**ADDENDUM 6**

PROJECT:  
**NEW NAPANEE WPCP**

| CHECKED BY:<br>J.B.  | <b>P5102</b>        |

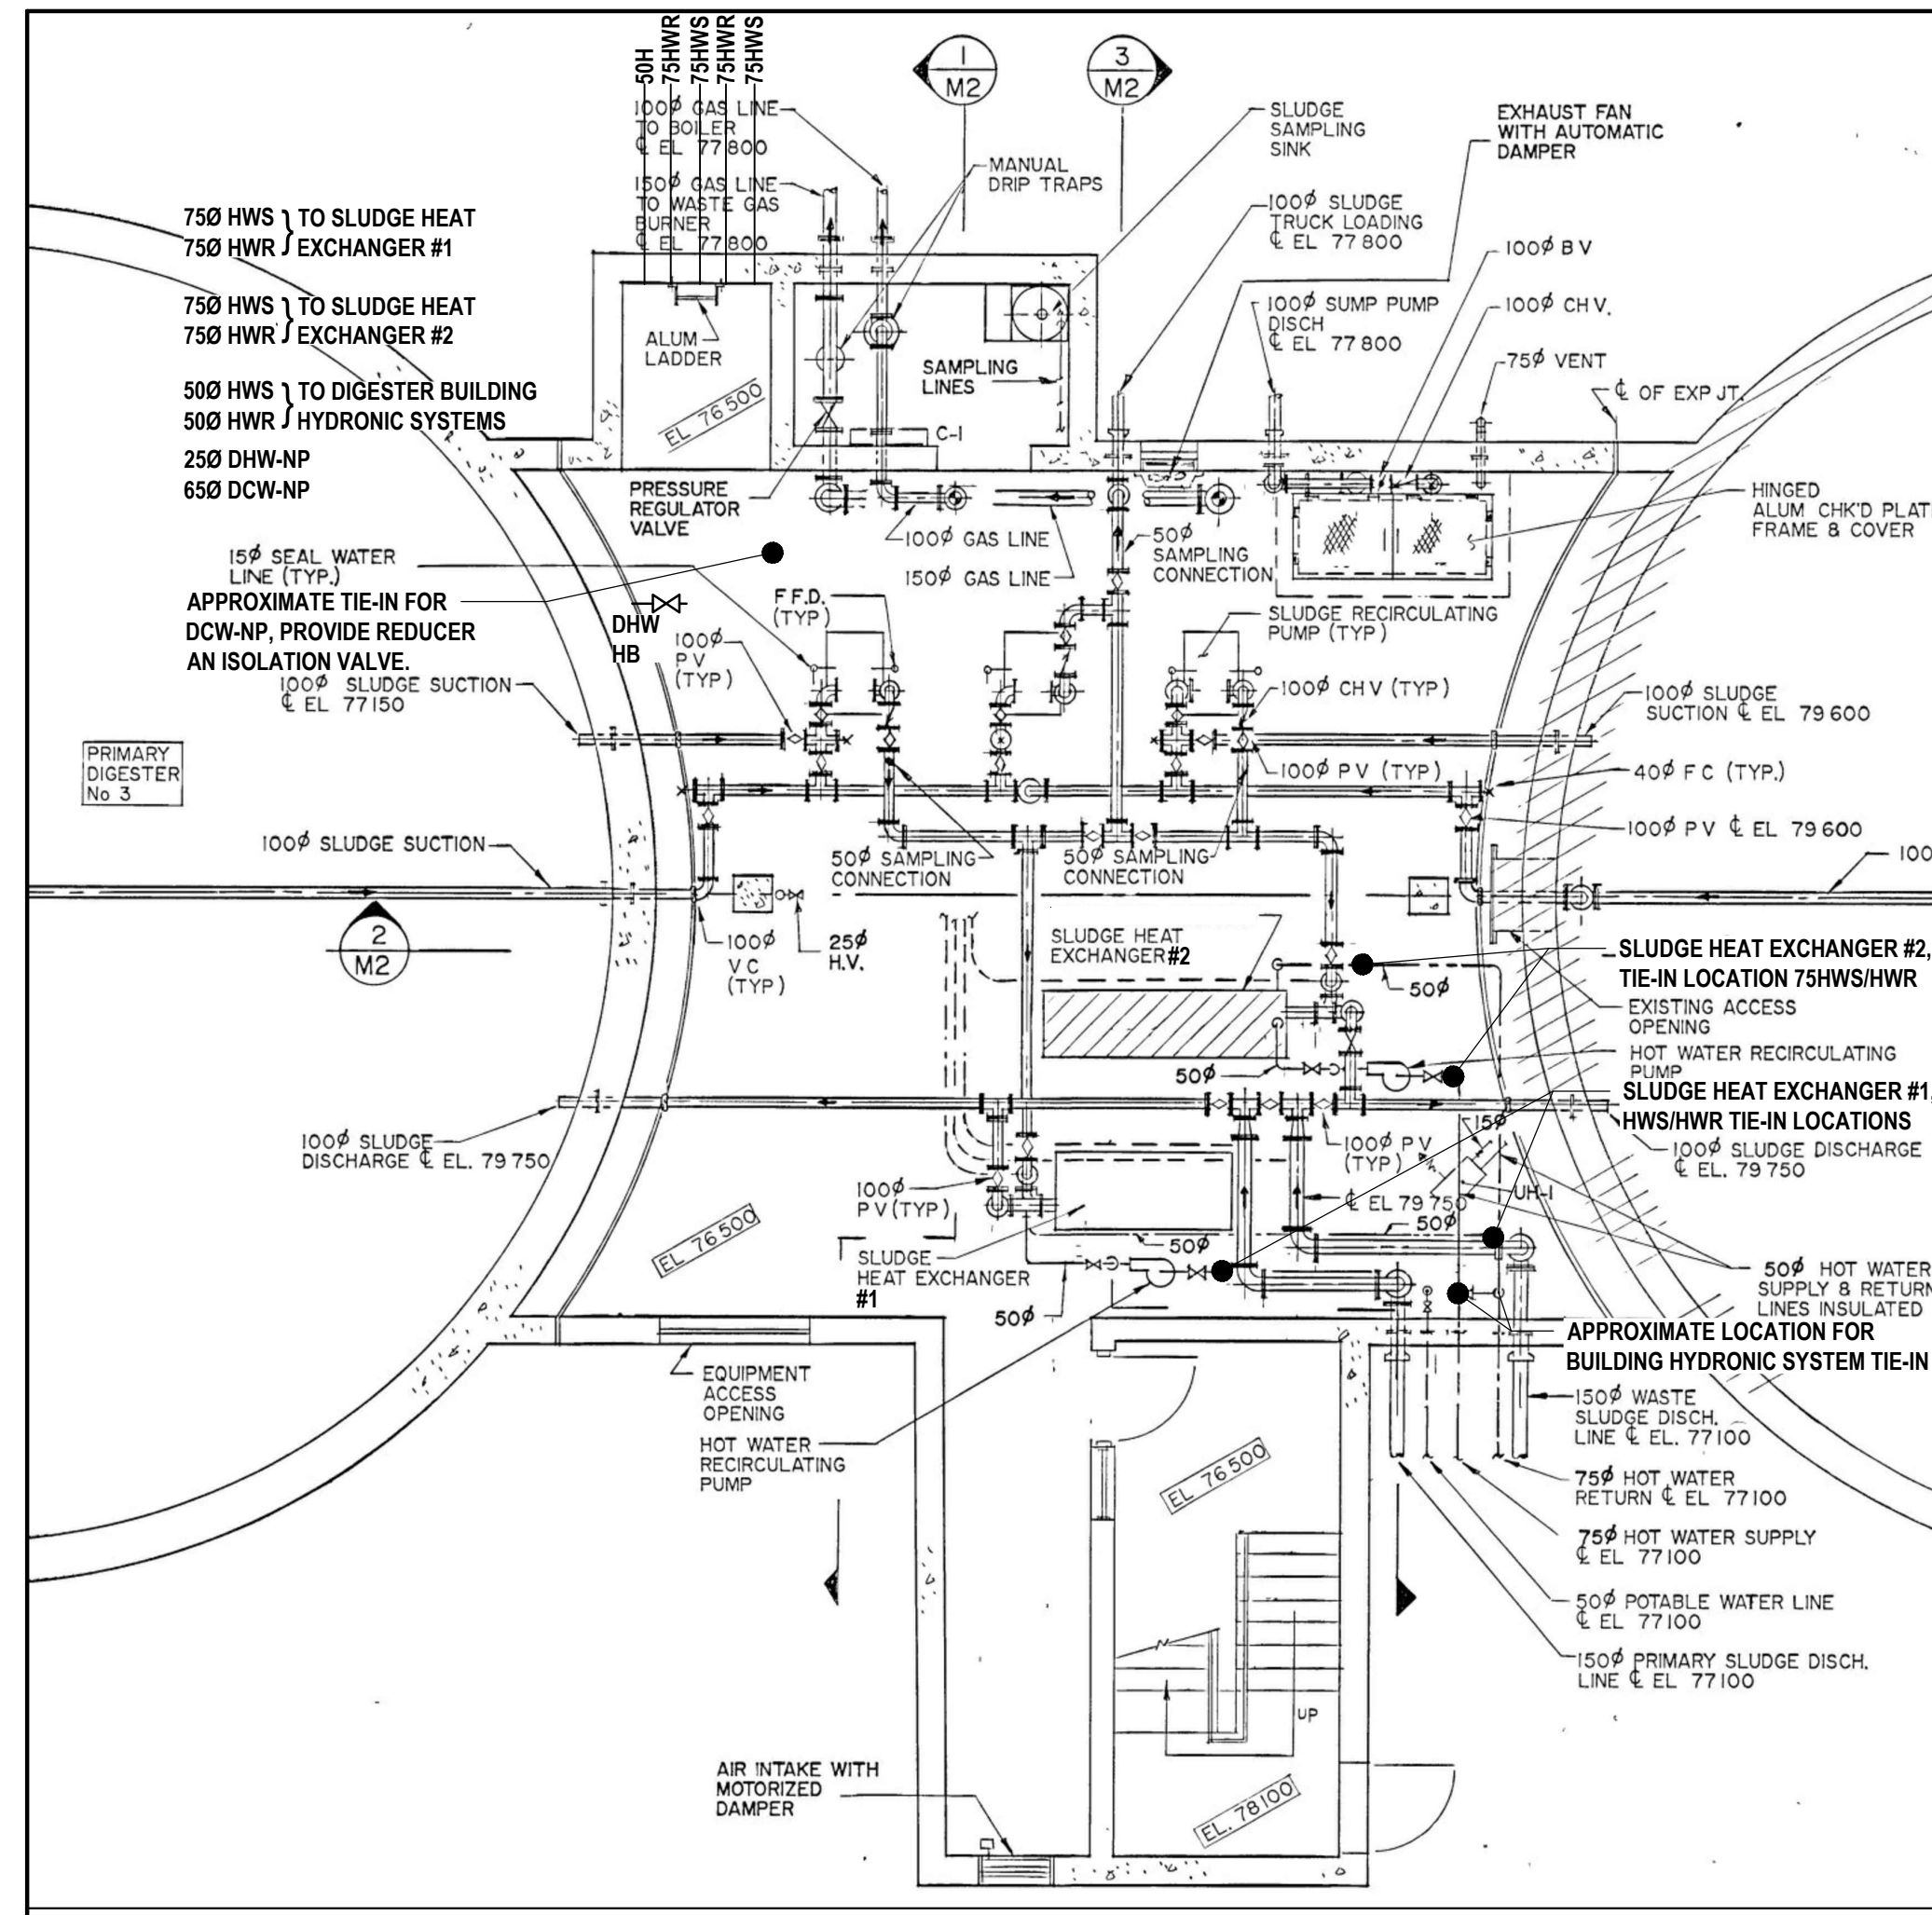
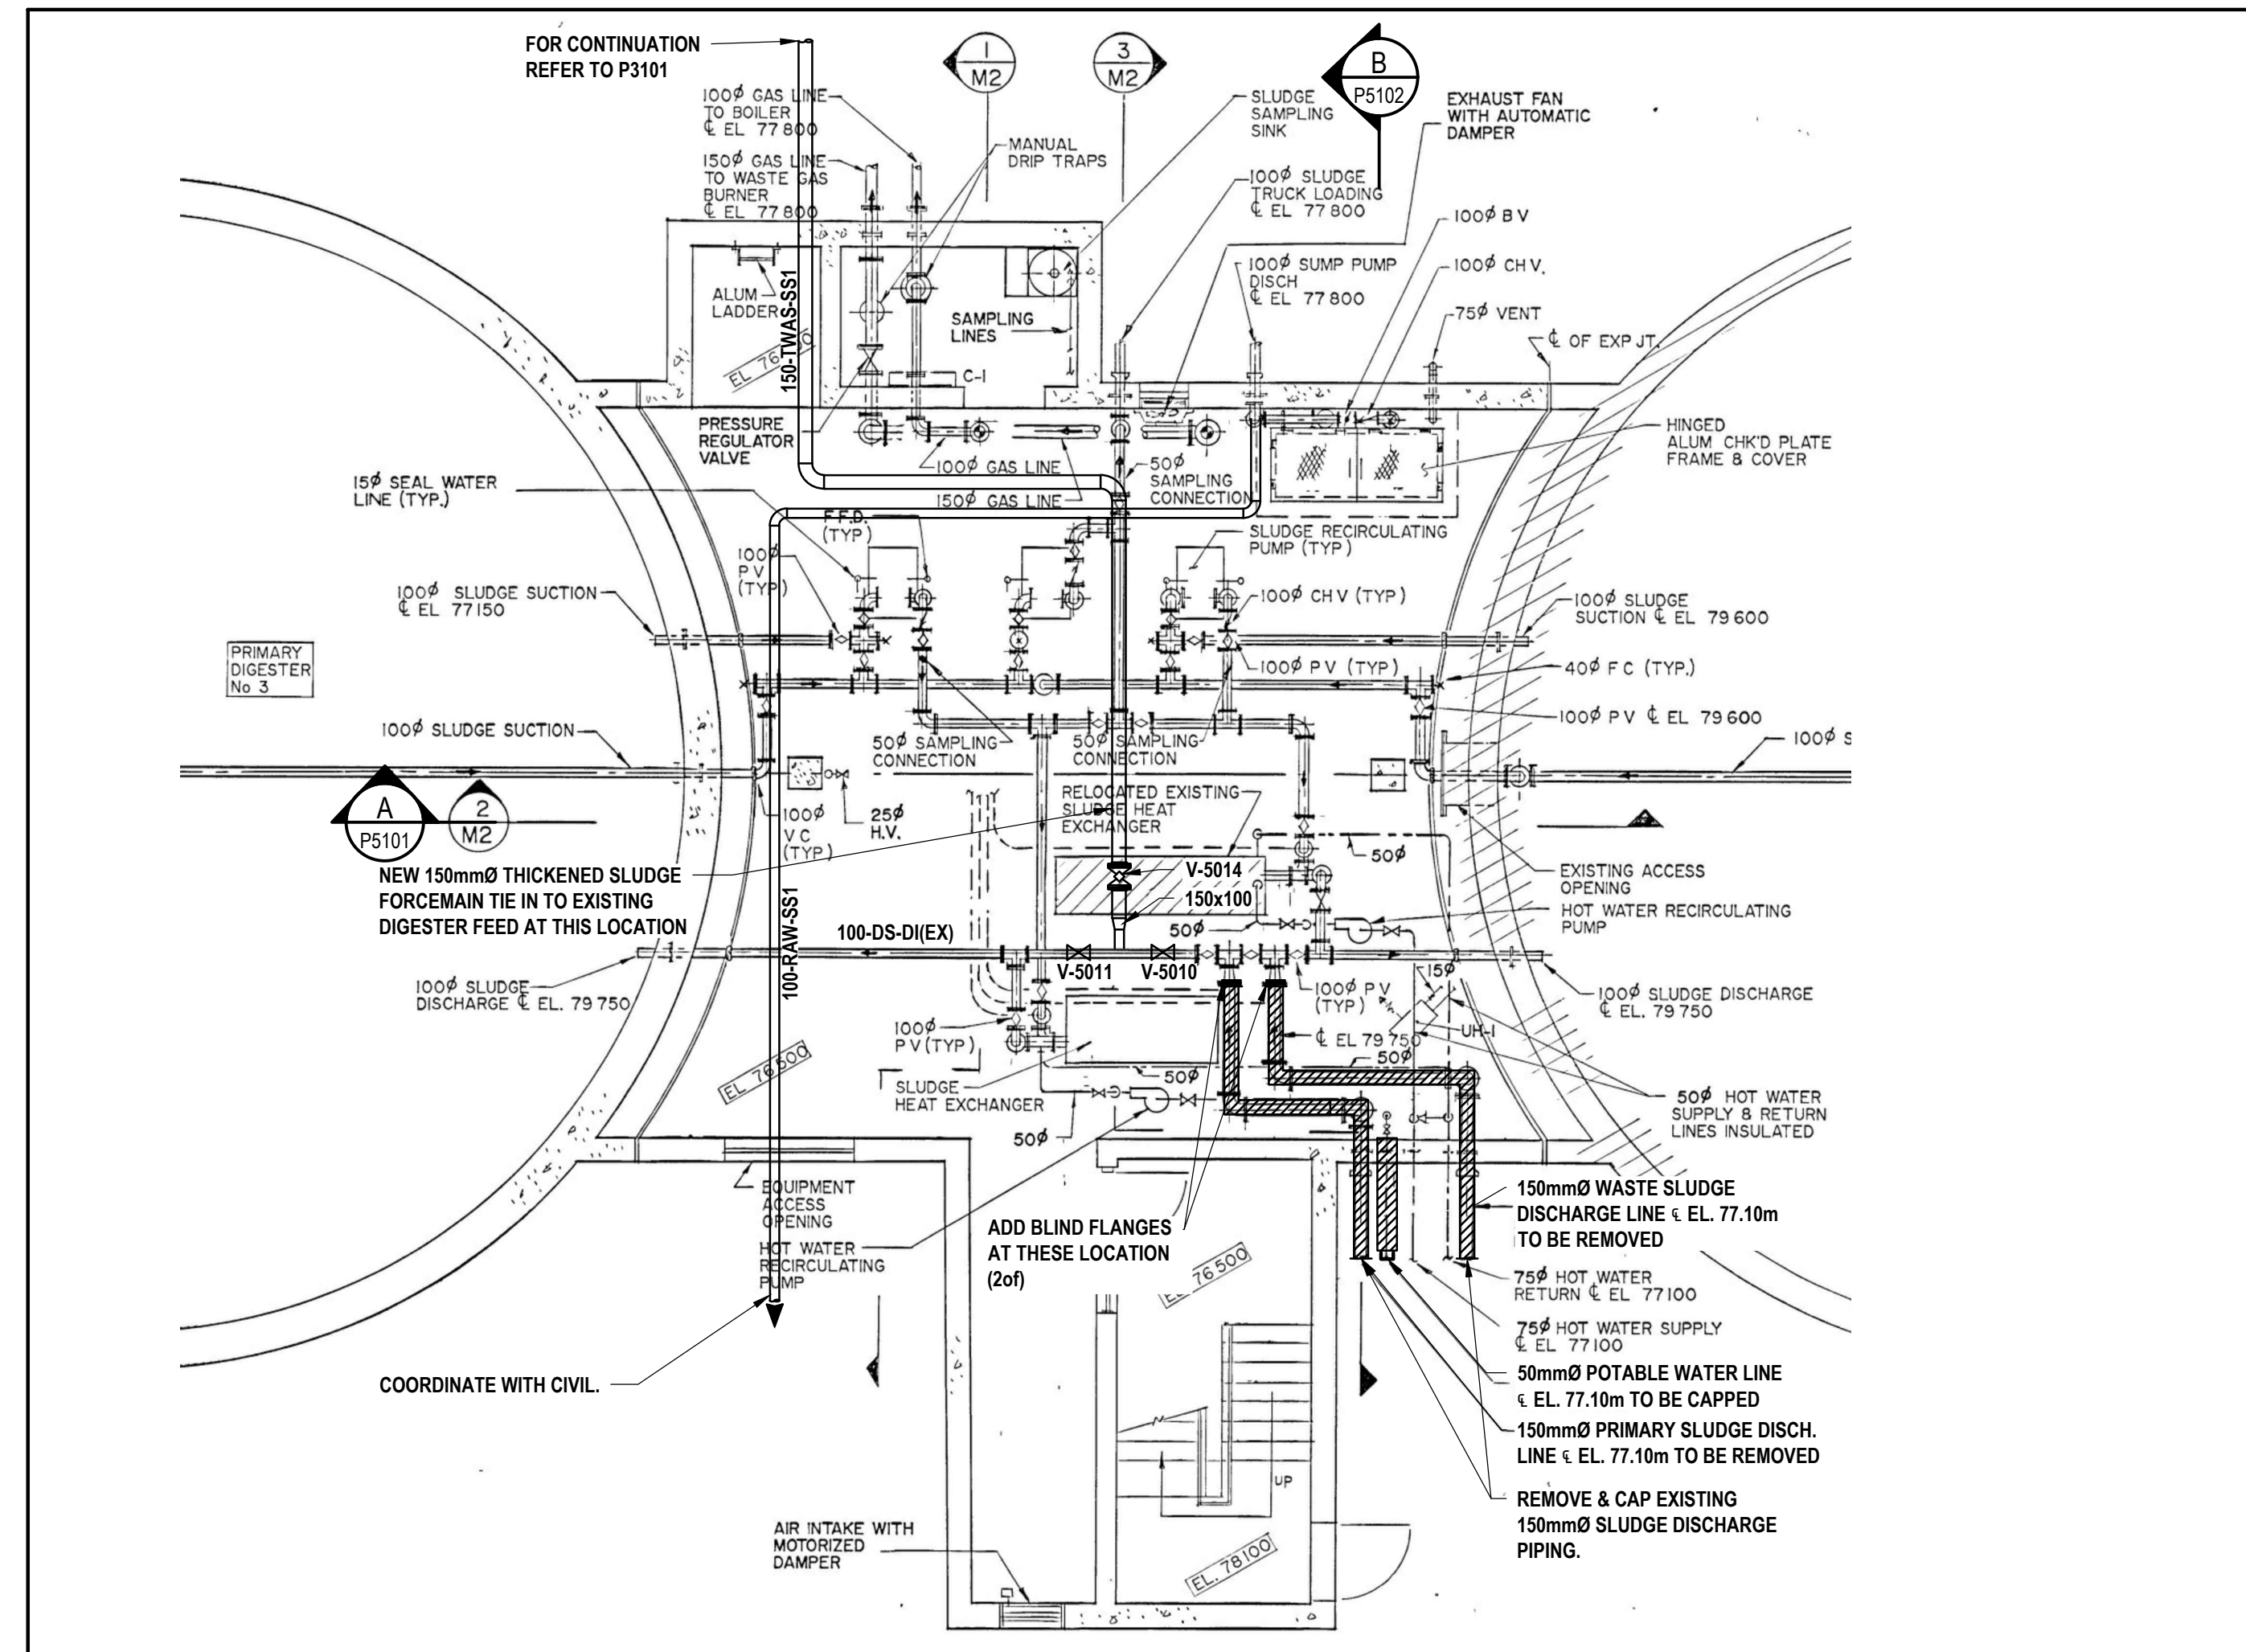
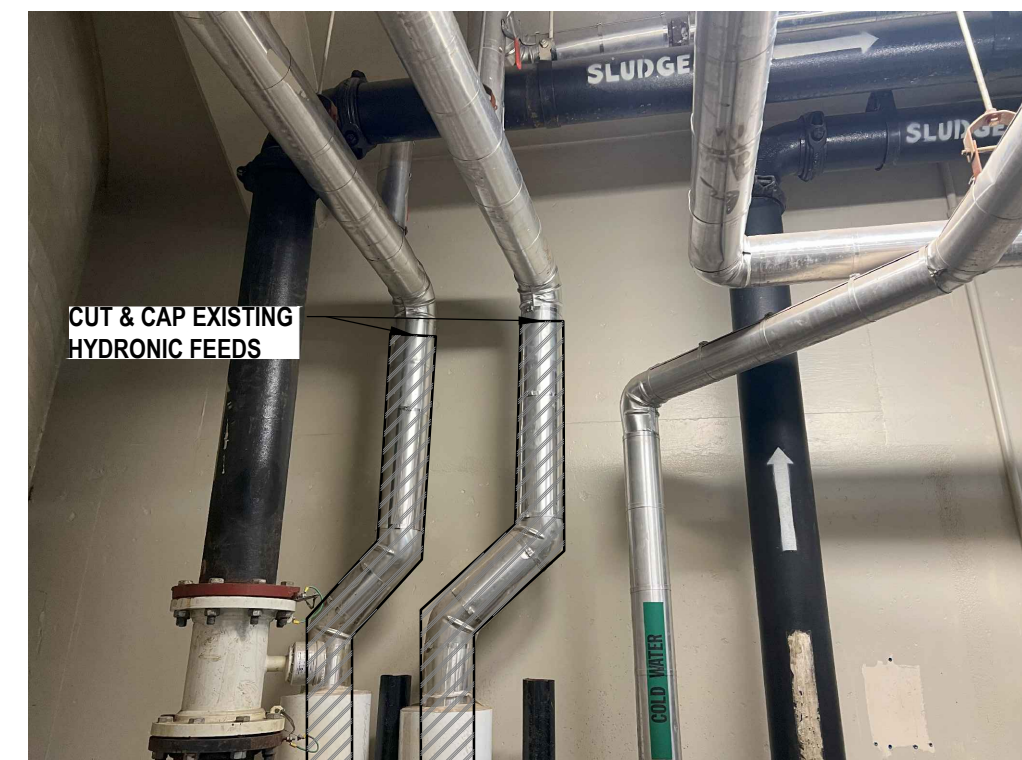
- .10 Drawing P5101
  - .1 **Amend** Drawing P5101 as per the attached.
- .11 Drawing P5102
  - .1 **Amend** Drawing P5102 as per the attached.
- .12 **Add** Drawing P5103 as per the attached.
